TECHNICAL BULLETIN

[Issue No.] HIME-T-P-0191A

[Title] Production discontinuation of the PLC MELSEC-F series high-speed counter block FX2N-1HC and FX2NC-1HC

[Relevant Models] MELSEC-F FX2N-1HC, FX2NC-1HC

1.1 FX2N-1HC (Production discontinuation)

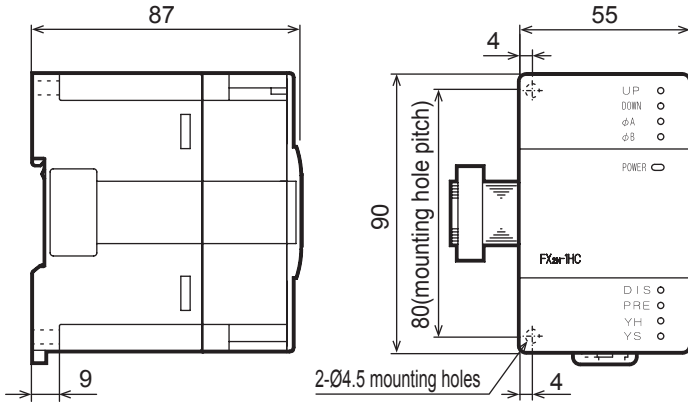
Major differences	Product size of the FX2NC-1HC and FX3U-2HC are the different size. FX2NC-1HC: (W) 20.2 mm × (D) 89 mm × (H) 90 mm FX3U-2HC: (W) 55 mm × (D) 87 mm × (H) 90 mm * FX2N-1HC and FX3U-2HC are the same in size.
	FX2NC-1HC and FX3U-2HC have a mounting hole in the different position. * FX2N-1HC and FX3U-2HC have a mounting hole in the same position.
	The number of channels is different. FX2N-1HC, FX2NC-1HC: 1 channel FX3U-2HC: 2 channels
	The current consumption FX2N-1HC, FX2NC-1HC: 5 V DC 90 mA (Supplied from the PLC internal power supply) FX3U-2HC: 5 V DC 245 mA (Supplied from the PLC internal power supply)
	Connectable PLCs FX2N-1HC, FX2NC-1HC: FX2N, FX2NC, FX3U, FX3UC FX3U-2HC: FX3U, FX3UC, FX5U, FX5UC
	The terminal layout and the shape of the connector are different.
